APPLICATION FOR URBAN DESIGN COMMISSION REVIEW AND APPROVAL

Responses to UDC draft meeting minutes dated September 20, 2006

Baer Insurance Building 9701 Brader Way Lot / Parcel 2 of Blackhawk Church Town Center Plat Madison, WI

DRAWING NAME:
FIRST FLOOR PLAN
SCALE: 1/8" = 1'-0"
DRAWN BY: AK
DATE:

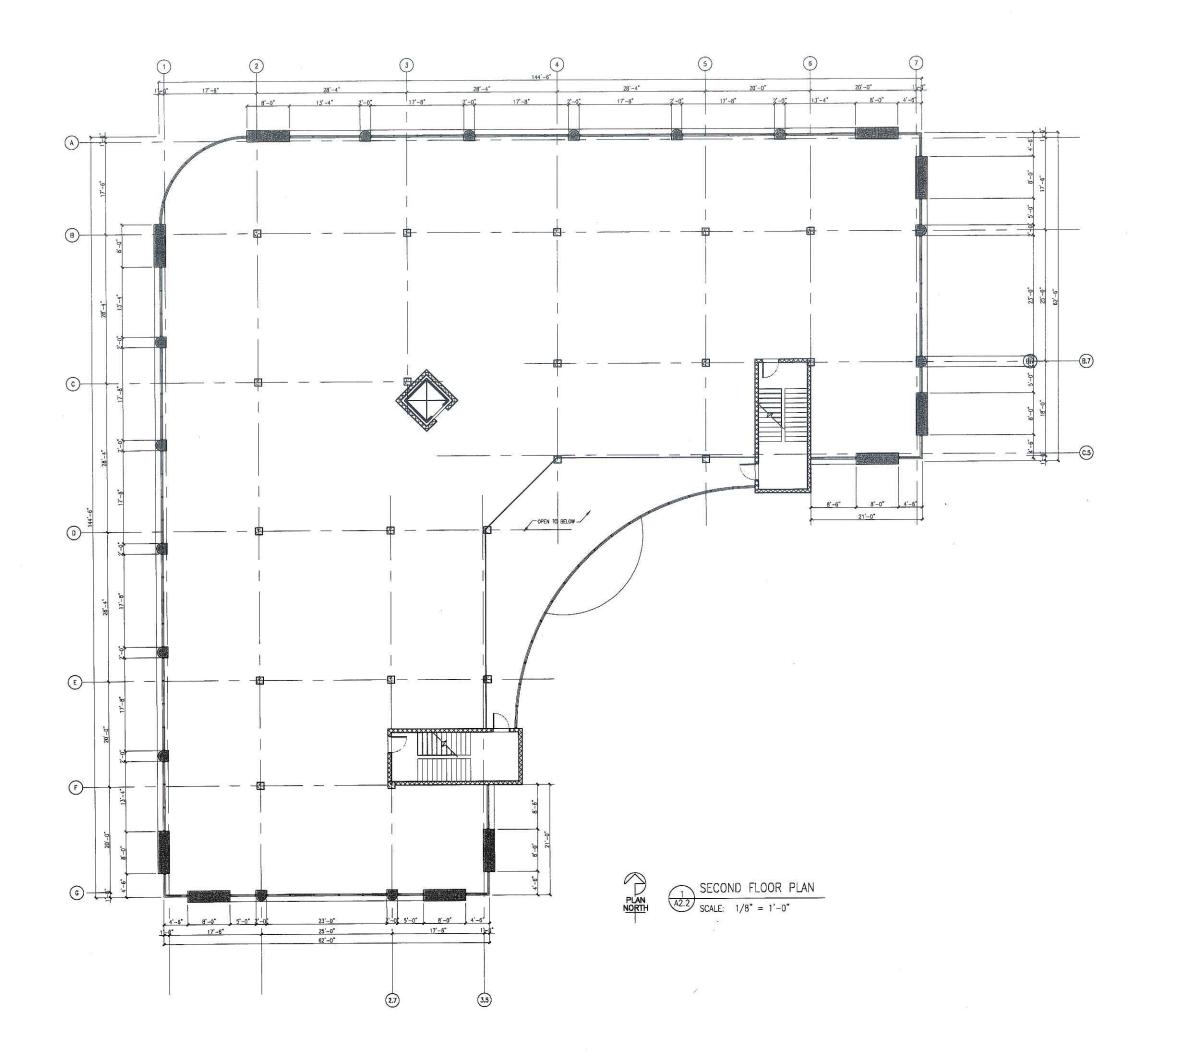
• Look at how pedestrians get from sidewalk to the front door; want to see a front door entry to the street, including protective features such as an overhang.

Corner entrance issue needs to be addressed appropriately.

• Building was intended to provide more of an urban feel. Building doesn't address corner at all; need to engage its other sides (street sides).

The pedestrian access from Brader has been significantly widened and accent trees have been added. A pedestrian access has also been added from Veritas. A first-floor building entry has been added to access Brader.

An entrance has been added to the north side of the building, to access Brader Way.

An entrance has been added to the north side of the building, to access Brader Way. In case the first floor tenant and/or use should change in the future, this same entrance type could be used in the other first-floor bays to provide street access.

DRAWING NAME:
SOUTH & SOUTHEAST
EXTERIOR ELEVATIONS
SCALE: 1/8"=1"-0"
DRAWN BY: AK

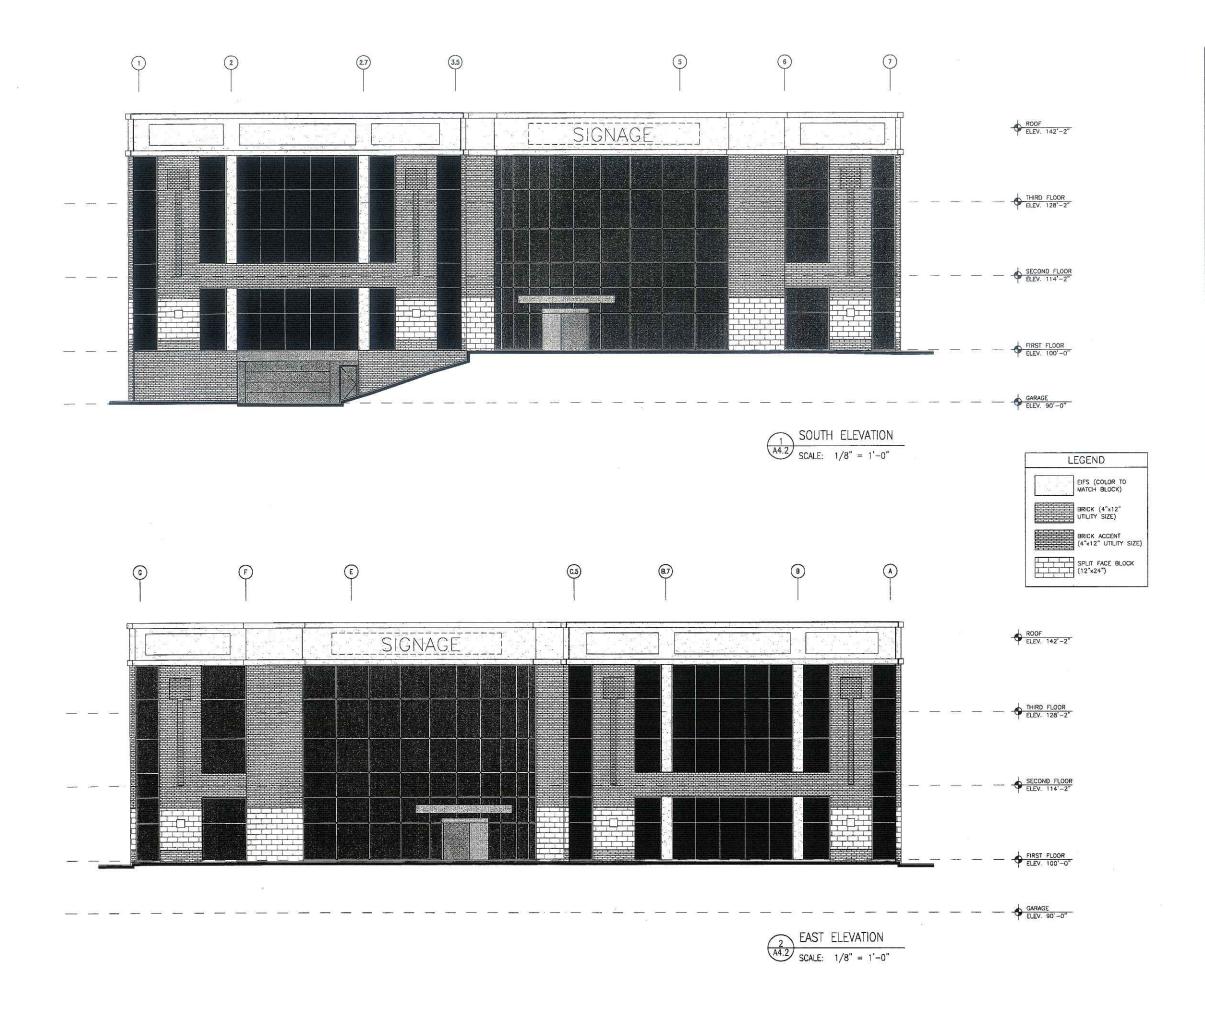
• Not clear on the elevations and plans on how glazing occurs, indented/curved.

• Given size of building, question the appropriateness of the size of brick needed, modular.

Provide elevation details necessary to show the size of brick.

The plans and elevations have been revised to show glazing and wall areas more clearly.

The actual brick sizing, a 4"x12" nominal size, has been show on the 1/8" scale elevations. I believe that this is an appropriately scaled brick for a 3 story commercial building in an "urban" setting. The standard modular size brick is a more residential-scaled application.

See preceeding response.
